FORMAL LETTER OF SUPPORT FOR PRIOR APPROVAL APPLICATION (ref: 2021/4149/P) FOR ONE ADDITIONAL STOREY AT NO. 7 CONYBEARE, LONDON NW3 3SD

Figure 1.2: Proposed façade with additional storey at No. 7 Conybeare

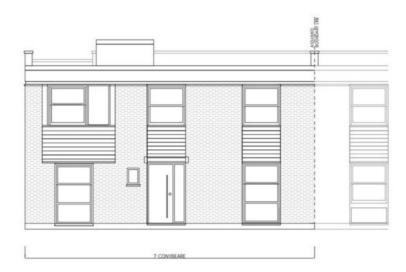
I support the principle of the additional storey at the property and would suggest that the internal floor to ceiling heights are at least 2.5 metres and preferably higher. This would ensure that the new floor accords with 'Standard 31' of the GLA 'Housing' Supplementary Planning Guidance (March 2016), as well as Part 8 of Policy D6 'Housing quality and standards' within the London Plan (March 2021).

In terms of design, I am supportive of the approach taken. In essence, the new floor mimics the existing brick, render and concrete coping stone to match the existing design. The additional floor also replicates the window arrangement and proportions of the main façade. This ensures that the extension positively responds to both the host property and the character of the wider Chalcot Estate, which dates from the 1960's.

I have provided a copy of the existing and proposed façade at Figures 1.1 & 1.2, respectively.

Figure 1.3: My personal proposed façade with additional storey at No. 7 Conybeare, which I feel would improve the verticality of the building
